## Response to HAM-ISI Watchdog Committee Recommendations

Assembled for the SEI team by Brian Lantz,  
LIGO-E0900075-v1, March 9, 2009

There was recently a review of the watchdog software for the HAM-ISI for use in Enhanced LIGO. The review committee assembled a list of required actions and suggested actions in LIGO E0900006-v1, *Review of HAM-ISI "Watchdog" safety software*. We have addressed the two required actions, and several of the suggested actions. This document describes those actions.

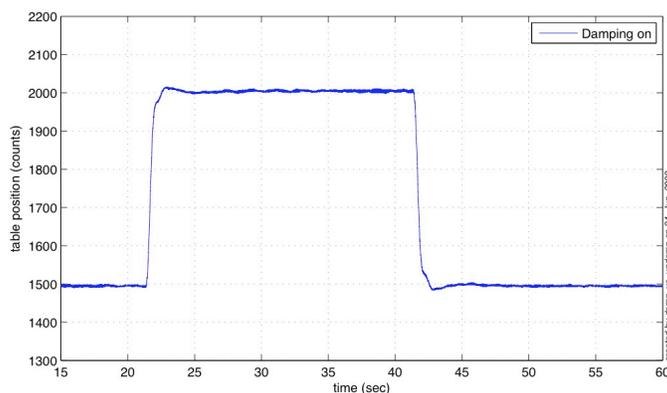
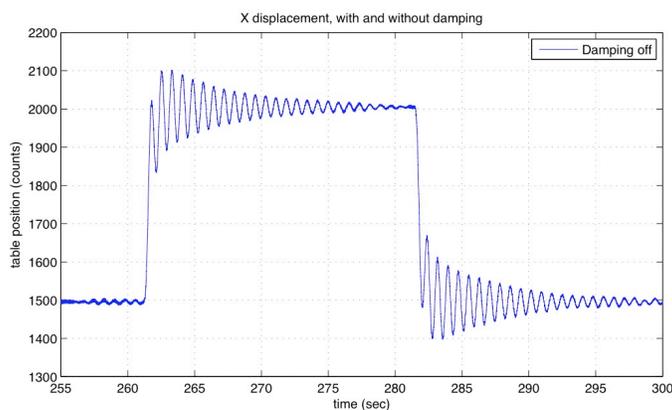
### 3. Justify complication caused by providing intermediate “damping only” fault states

In our experience, in the case of faults, it is usually best to leave the damping loops on. This is especially true once the system is commissioned, and the major source of watchdog triggers is either large environmental disturbances or drive commands. In these cases, a controlled shutdown is safer than simply disabling all the drivers, because if there are any offsets being maintained by the controllers, or there are large external drives, the damping system allows the table to return smoothly to its neutral position.

An example of the impact of the damping loops on the response of the system to a step drive is shown below in figure 3. This plot is drawn from an entry in the LHO log by Jeff Kissel on June 4, 2008.

The step example is quite important, since that is similar to the type of event one would expect when the watchdog is triggered, because if there is any bias being held by the isolation loops (to align the OMC, for example), then that bias command will be immediately turned off by the watchdog. There is some lowpass filtering of the signal in the coil drivers (which is present for these measurements), but the damping loops clearly reduce the amount of shaking on the table when a command bias is introduced or removed.

Figure 4a. Undamped response of the ETF table, as seen by geophone H1, when the table is pulled sideways to one stop and released (released at about 10 sec on this plot). The sensor goes in and out of saturation for about 40 seconds, then continues to ring down for another 25 seconds or so.

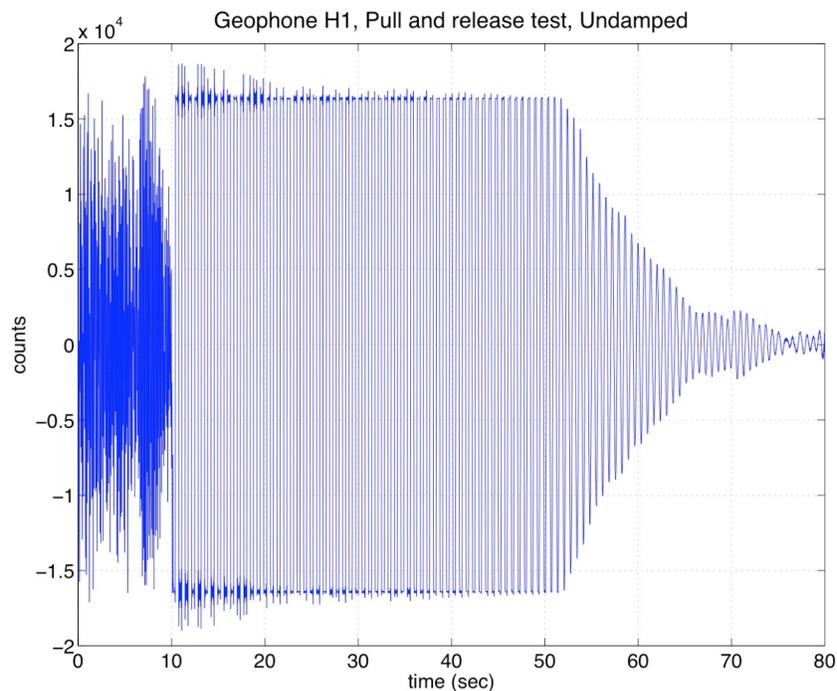
#### **4. Verify stability of “damping only” loops under correlated sensor loss**

The damping loops are quite robust. They can be turned on and off in any combination in any order, which has been demonstrated repeatedly. A failed sensor is practically equivalent to turning off the input to the control filter, which is how we typically turn on and off individual damping loops. They damping loops operate even when the sensors are driven into saturation, as can be seen in figure 4.

By comparing the time traces in figures 4a and 4b, we see that even with sensor saturations, the damping loops perform very well. This experiment is described in more detail in the ETF log at <http://ligo.phys.lsu.edu:8080/ETFseismic/1077>.
